Re: Proposed Townhomes at Woodbank 0 Warburton Avenue

As the Architect representing PTG Development, LLC, owner of 0 Warburton Avenue, I am submitting the attached revised drawings, dated May 4, 2017, describing six new townhouses at 0 Warburton Avenue, for site plan, view preservation, and steep slopes review. Our submission consists of the following drawings:

In response to comments made by the Planning Board at the meeting on March 16, 2017, the drawings were revised, and additional drawings were prepared, as follows:

WEST ELEVATION - COMPARISON TO PREVIOUS SUBMISSION

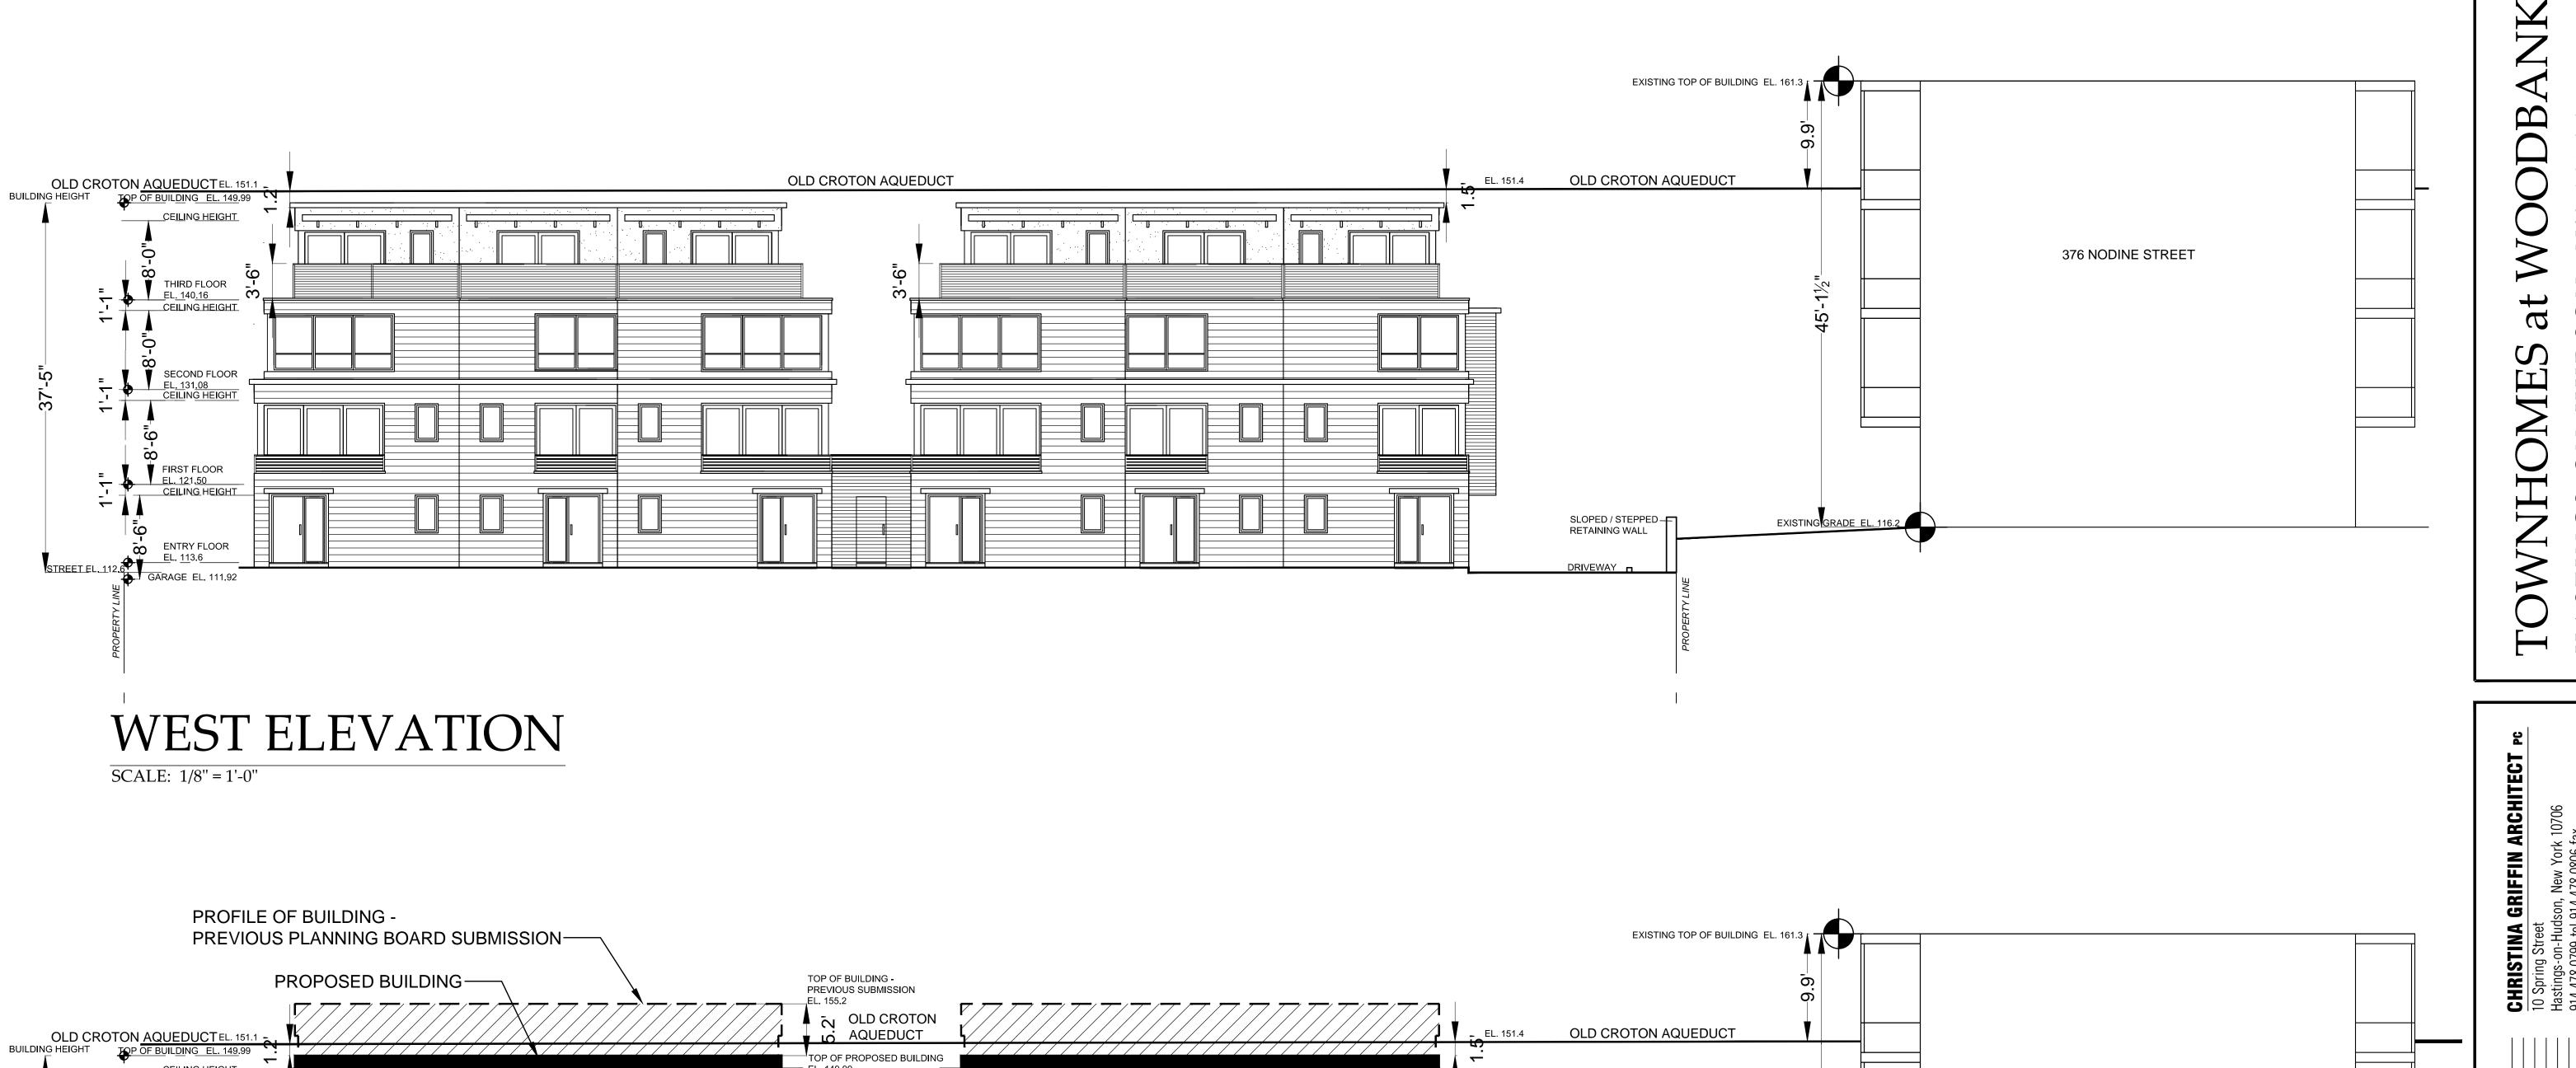
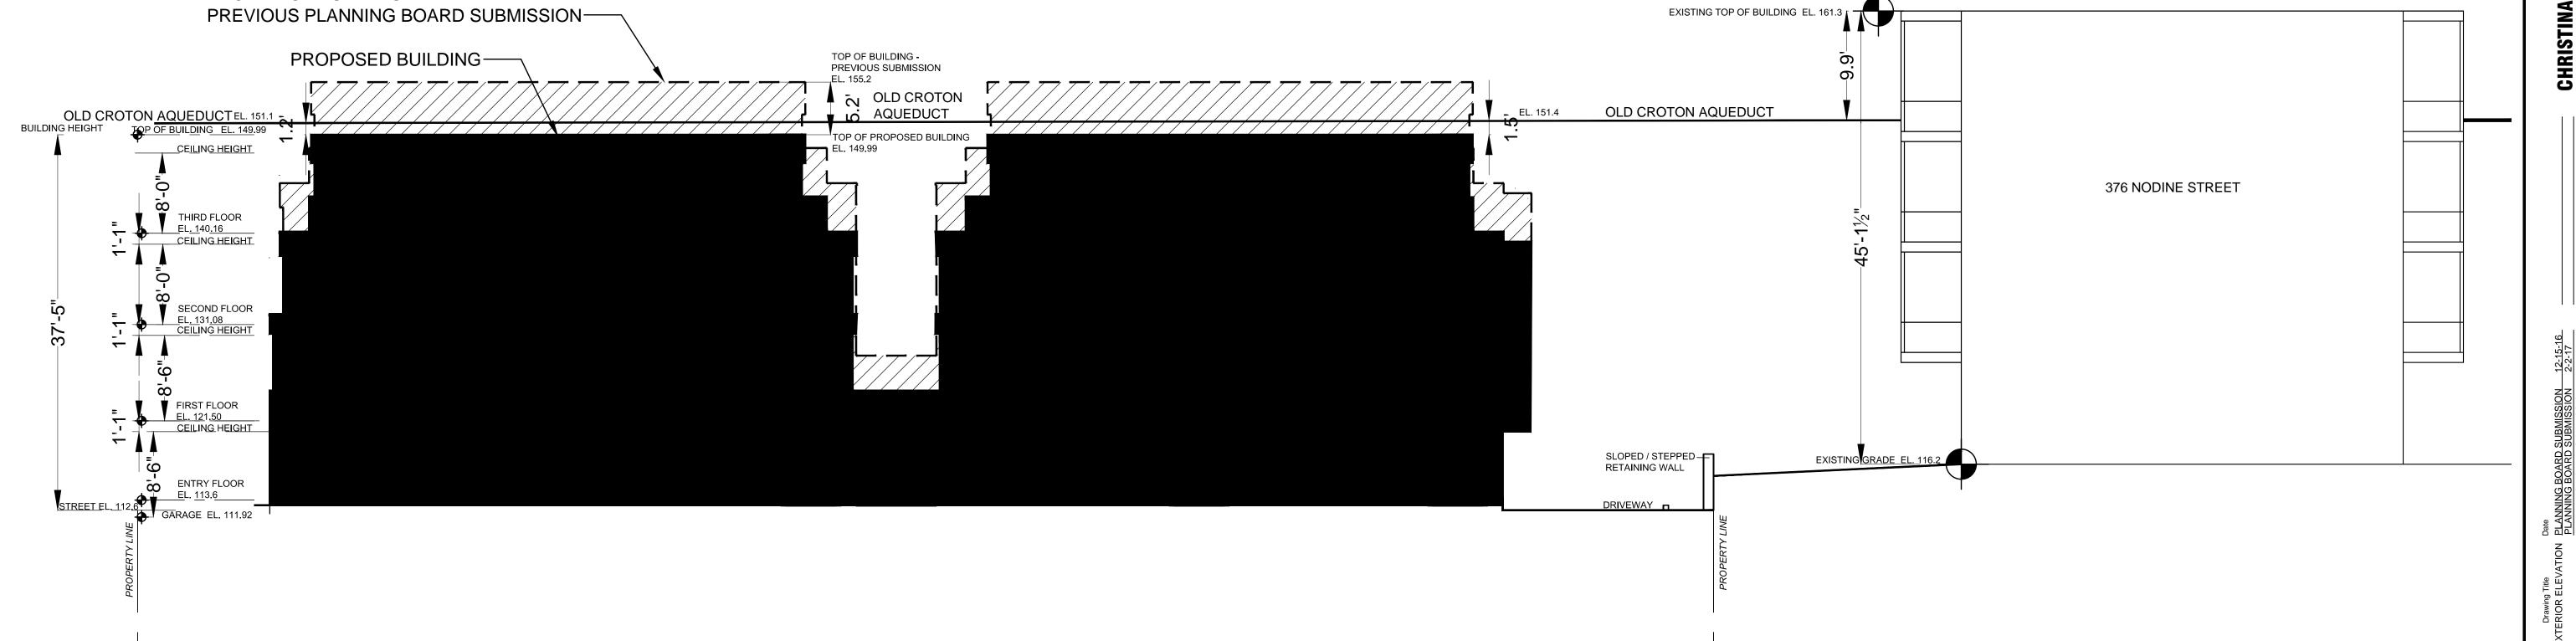
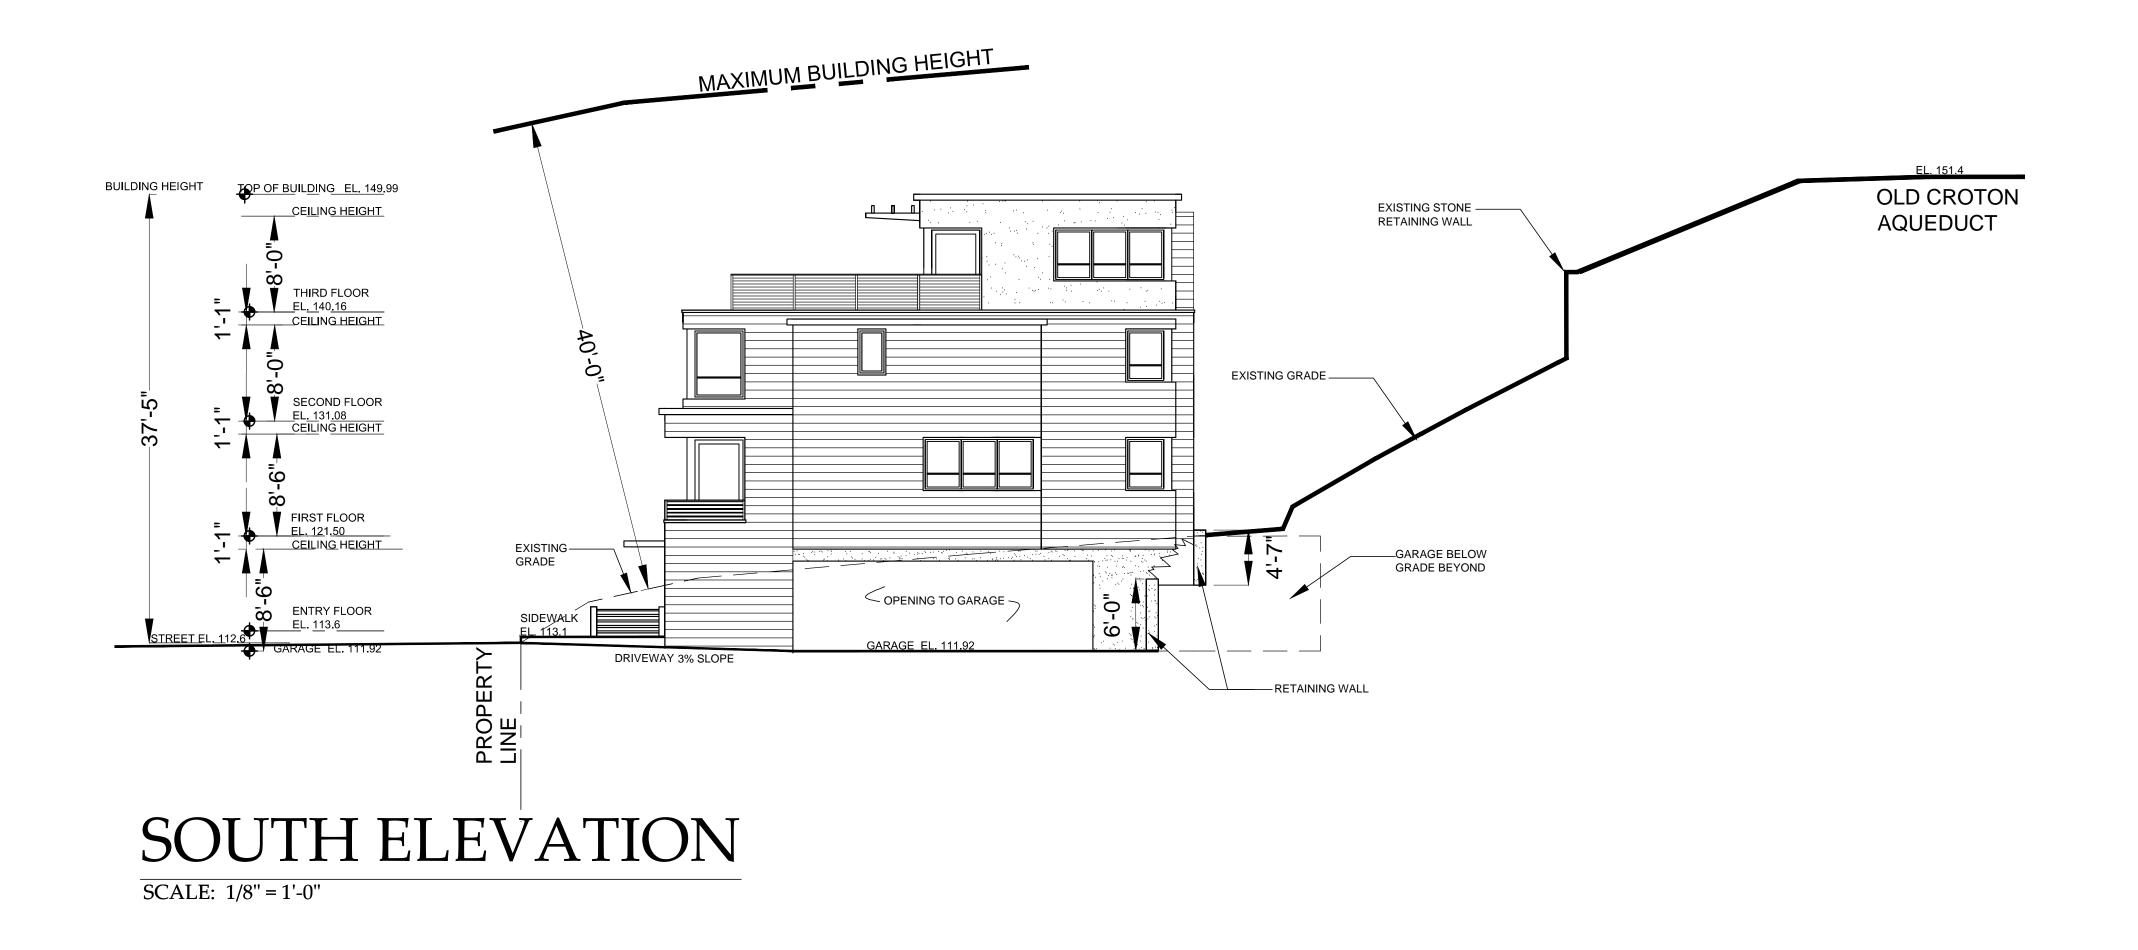
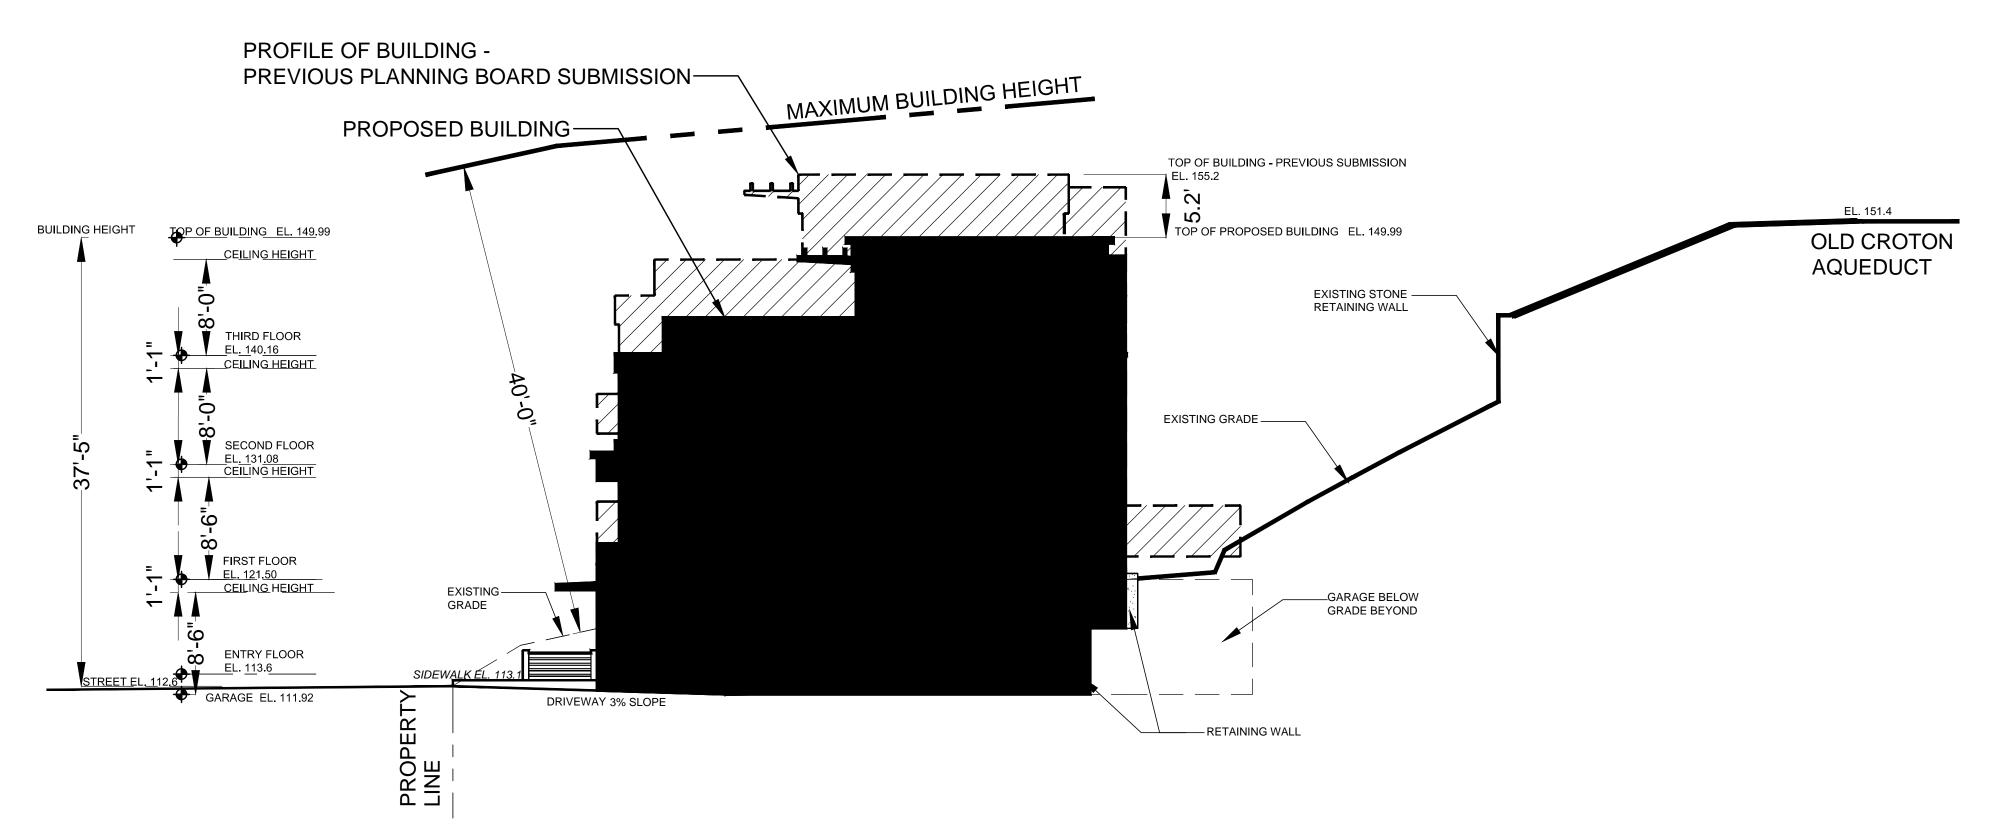
- 3. The total open space area has increased to 9,294 SF from 7,836 SF.
- 4. The proposed building is 5.2 feet lower than the previously submitted building, due to the newly established street elevation of 112.6 and due to the lowering of the ceiling heights at the garage, first floor and second floor. See revised elevations A-4 – A-7, and revised view studies VP-1 – VP-12.
